Planning reference: 3/2025/0873

Location: Land at Springwood Drive, Whalley, BB7 9XL

Proposal: Construction of six detached dwellings with associated parking and landscaping at land off Springwood Drive

We refer to the latest letter from the Environment Agency dated 26th May 2026 in which the Environment Agency maintained their objection to the planning application as the Environment Agency are not yet satisfied that the development would be safe without exacerbating flood risk elsewhere. The reasons being given are below along with our responses.

TRI-4353-01

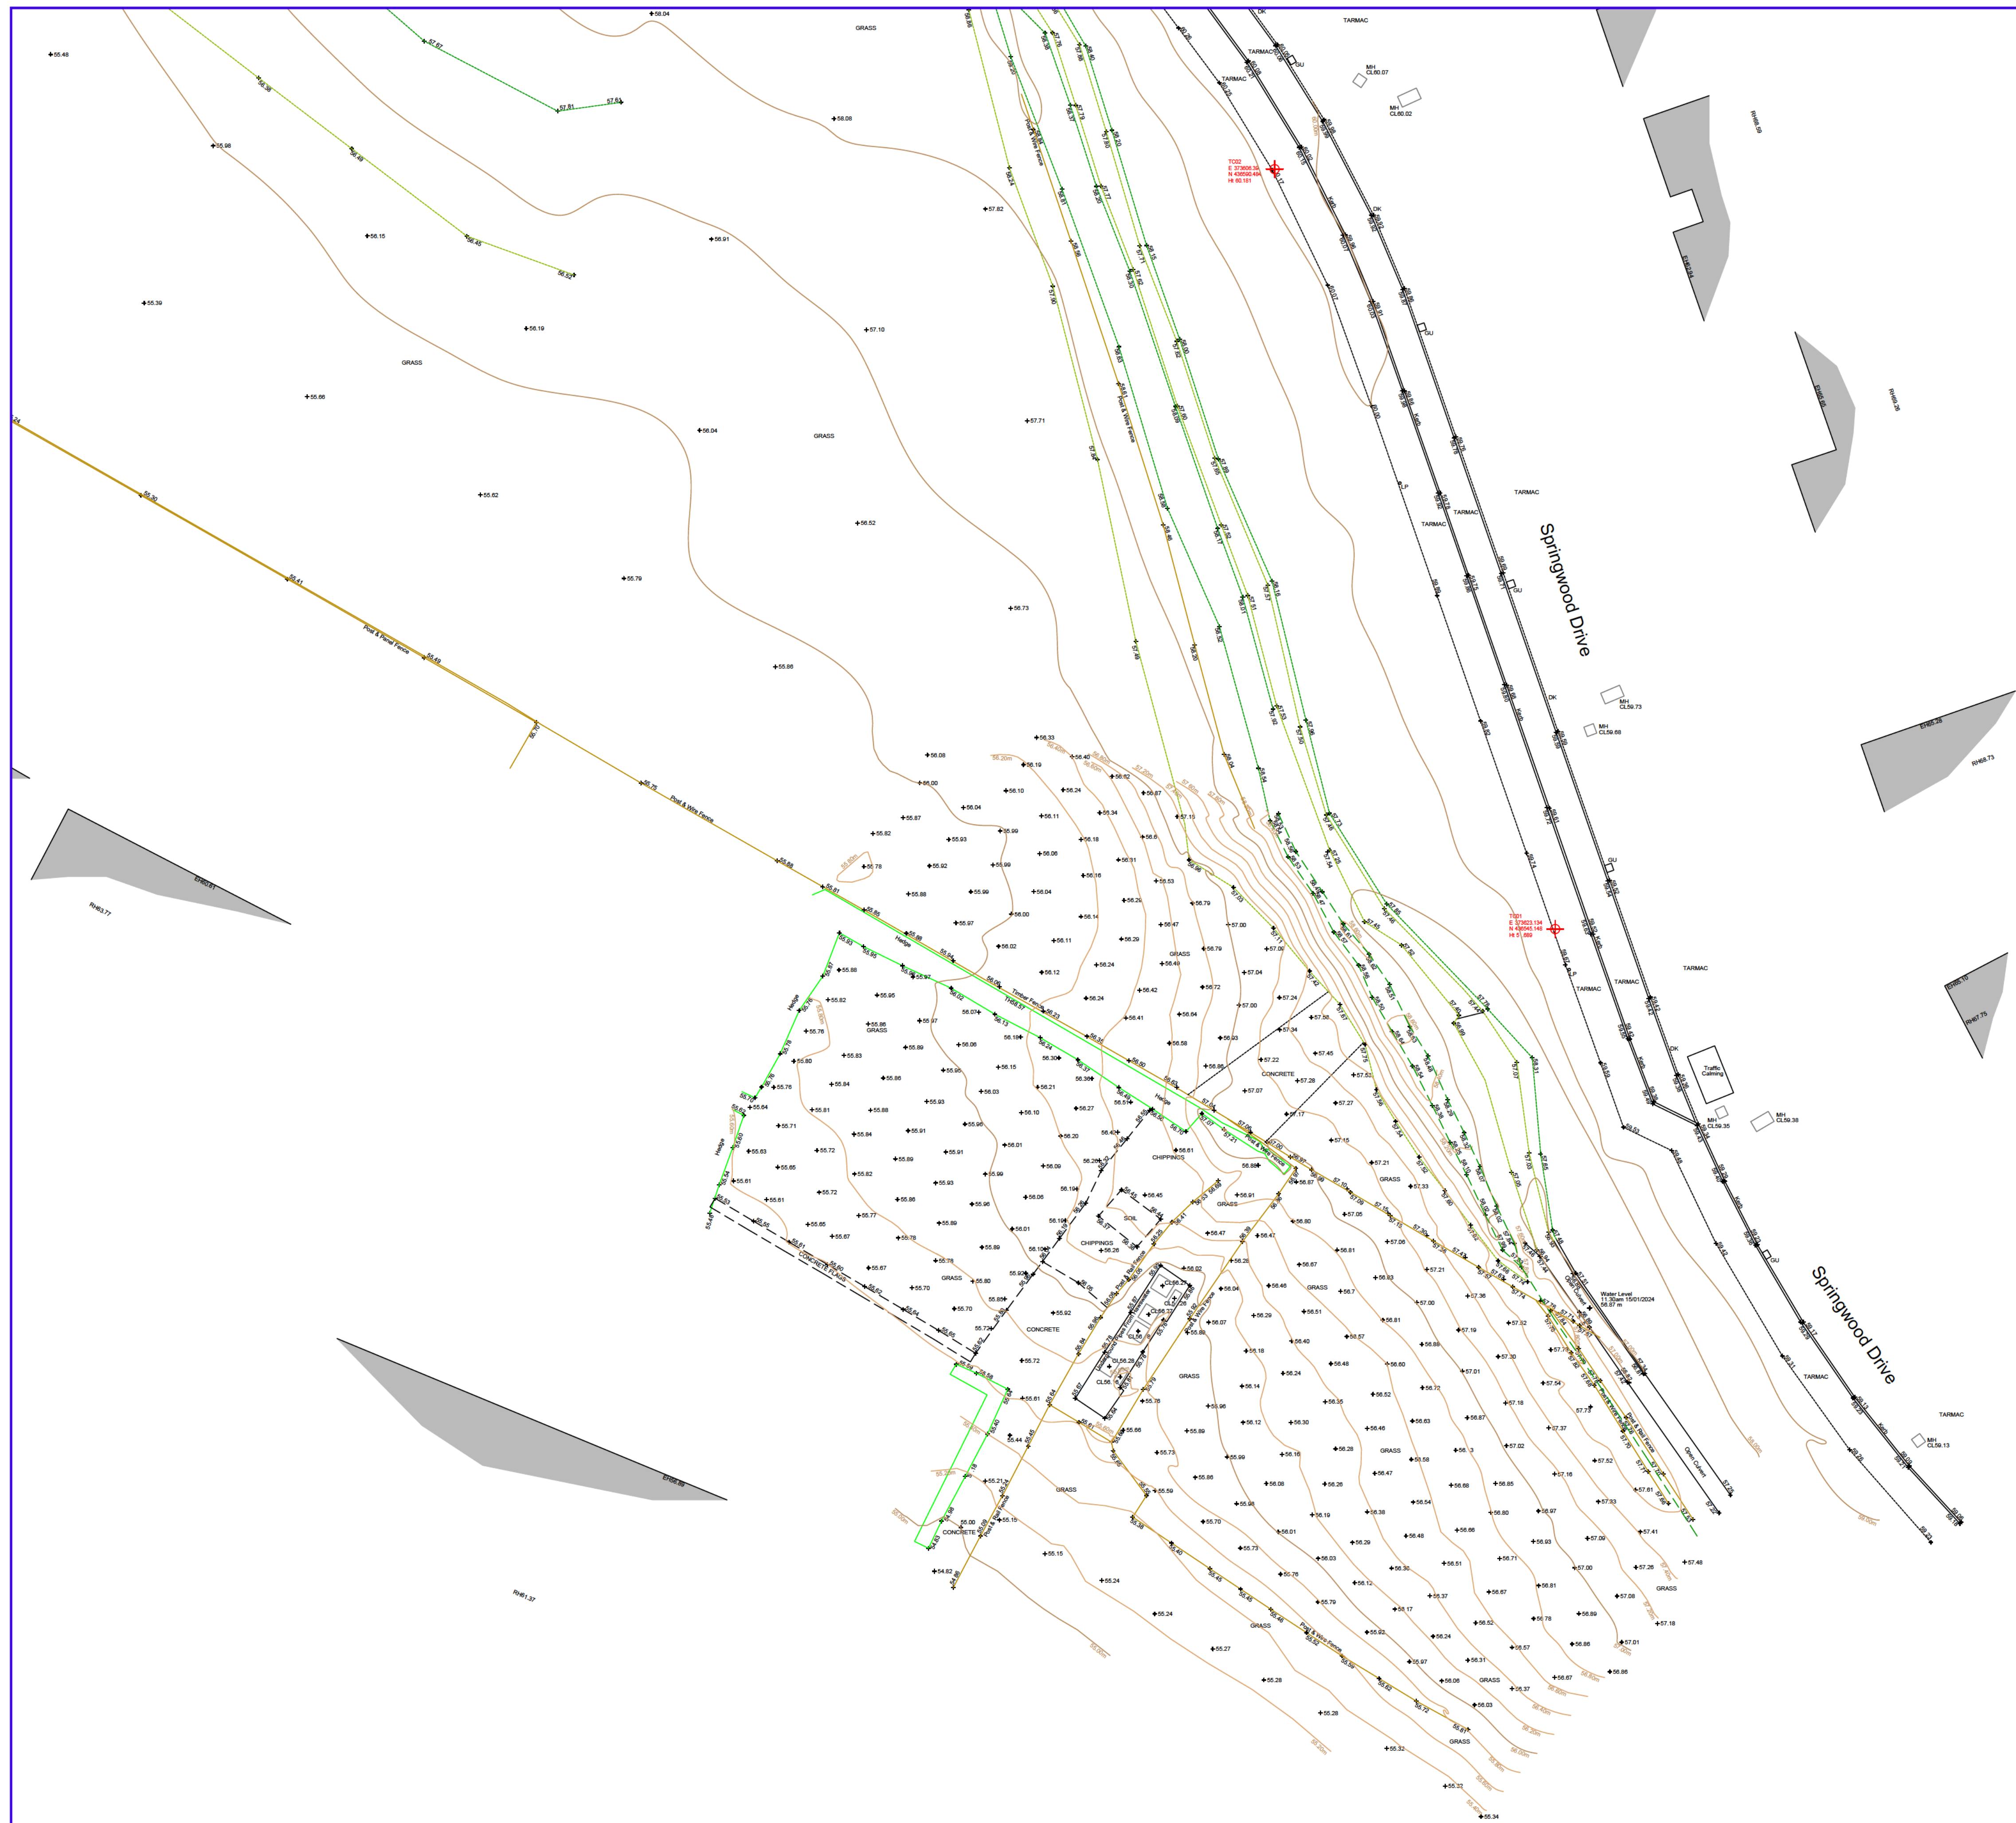
However, approx. 5m to the south of Node Reference 931620 in the extreme south eastern corner of the development site, the additional topographical survey has identified a low spot within the western bank where there may be a plausible flow path for floodwaters to overtop the western bank of the Wiswell Brook during the 0.1% AEP event.

The detailed topographical survey was provided with our earlier letter and part has been attached to this letter. Importantly, it has been marked up to show that any potential overtopped floodwaters, should they occur at the location approx. 5m to the south of Node Reference 931620, i.e., in the very extreme south eastern corner of the development site, will not ‘fan out’ into the Flood Zone 2 extent at the south of the site where ground level raising is proposed. When correctly interpreting the existing ground levels it can be seen from the marked up survey that the potential for any overtopped floodwaters will flow away from the development site (the limit of the southern site boundary is defined / confirmed by the red line on the topographical survey). The downward gradient of the natural slope of the land away from the proposed development is very evident and therefore any potential flood routing will not be routed back to the south of the development site.
